Intersection ID: 21209	Main Street: GALLERIA_BV	Cross Street: SARDIS_RD_NORTH	Location:	NW
ADA ID: 18F7AB7E8A7C	Ramp Type: Perp	Initial Pass/Fail: Fail	Overall Compliance: No	Severity Score: 21.25

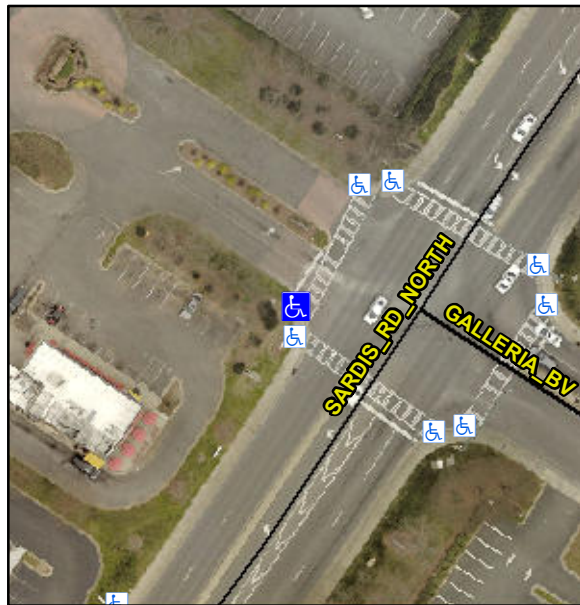
Not Found, R304.5.1, R304.5.3

Compliance	Description	Data	Compliance	Description	Data
N/A	Ramp Length (in)	70.0	Yes	Ramp Slope (%)	5.5
No	Ramp Width (in)	36.0	No	Ramp XSlope (%)	5.2
N/A	Flare Type LT	N/A	N/A	Flare Type RT	N/A
N/A	Flare Slope LT (%)	N/A	N/A	Flare Slope RT (%)	N/A
N/A	Flare Traversable LT?	N/A	N/A	Flare Traversable RT?	N/A
N/A	Landing Length (in)	N/A	N/A	DWS Provided?	N/A
N/A	Landing Width (in)	N/A	N/A	DWS Contrast?	N/A
N/A	Landing Slope (%)	N/A	N/A	DWS Length (in)	N/A
N/A	Landing X Slope (%)	N/A	N/A	DWS Full Width?	N/A
N/A	Landing Curb? (Y/N)	N/A	N/A	DWS Offset (in)	N/A
N/A	Shared Landing?	N/A			
N/A	Gutter Ponding?	N/A	N/A	Gutter Slope (%)	N/A
N/A	Gutter Lip Ht (in)	N/A	N/A	Gutter X Slope (%)	N/A
N/A	Painted X Walk1?	Yes	N/A	Painted X Walk2?	N/A
	X Walk 1 Direction	To NE		X Walk 2 Direction	N/A
N/A	X Walk 1 Width (in)	81.0	N/A	X Walk 2 Width (in)	N/A
	X Walk 1 Slope (%)	1.4		X Walk 2 Slope (%)	N/A
	X Walk 1 X Slope (%)	2.5		X Walk 2 X Slope (%)	N/A

Remove & Replace Entire Ramp.
